Access Compliance Report

Public Rights-of-Way

(Curb Ramps)

Intersection ID: 27197	Main Street: BALLANTYNE COMMONS PY	Cross Street: CRESTWOOD DR	Location: NW
ADA ID: A0356558197E	Ramp Type: Perp	Initial Pass/Fail: Fail	Overall Compliance: No
Severity Score: 22.5			
Codes/Mitigation Info/Possible Solution		Field Measurements/Component Compliance

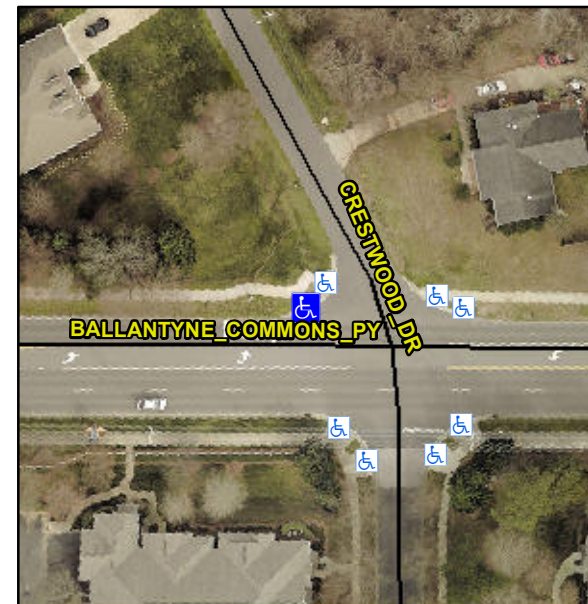
R304.5.1, R304.2.2, R304.5.3

Compliance	Description	Data	Compliance	Description	Data
N/A	Ramp Length (in)	90.0	No	Ramp Slope (%)	10.9
No	Ramp Width (in)	47.0	No	Ramp XSlope (%)	3.6
N/A	Flare Type LT	N/A	N/A	Flare Type RT	N/A
N/A	Flare Slope LT (%)	N/A	N/A	Flare Slope RT (%)	N/A
N/A	Flare Traversable LT?	N/A	N/A	Flare Traversable RT?	N/A
N/A	Landing Length (in)	N/A	N/A	DWS Provided?	N/A
N/A	Landing Width (in)	N/A	N/A	DWS Contrast?	N/A
N/A	Landing Slope (%)	N/A	N/A	DWS Length (in)	N/A
N/A	Landing X Slope (%)	N/A	N/A	DWS Full Width?	N/A
N/A	Landing Curb? (Y/N)	N/A	N/A	DWS Offset (in)	N/A
N/A	Shared Landing?	N/A			
N/A	Gutter Ponding?	N/A	N/A	Gutter Slope (%)	N/A
N/A	Gutter Lip Ht (in)	N/A	N/A	Gutter X Slope (%)	N/A
N/A	Painted X Walk1?	No	N/A	Painted X Walk2?	N/A
	X Walk 1 Direction	To SE		X Walk 2 Direction	N/A
N/A	X Walk 1 Width (in)	N/A	N/A	X Walk 2 Width (in)	N/A
	X Walk 1 Slope (%)	11.1		X Walk 2 Slope (%)	N/A
	X Walk 1 X Slope (%)	2.1		X Walk 2 X Slope (%)	N/A

Remove & Replace Entire Ramp.
